Access Compliance Report

Public Rights-of-Way

(Pedestrian Signals)

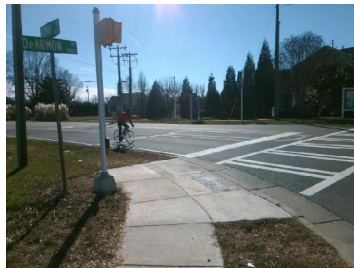
PROW/ADA: R209.1, TMUTCD 4e.08, R406.2, R404.7.2, MUTCD 4e.10

Possible Solutions: Replace Signal Push Button With APS Button on New Post. Remove & Relocate Sign.
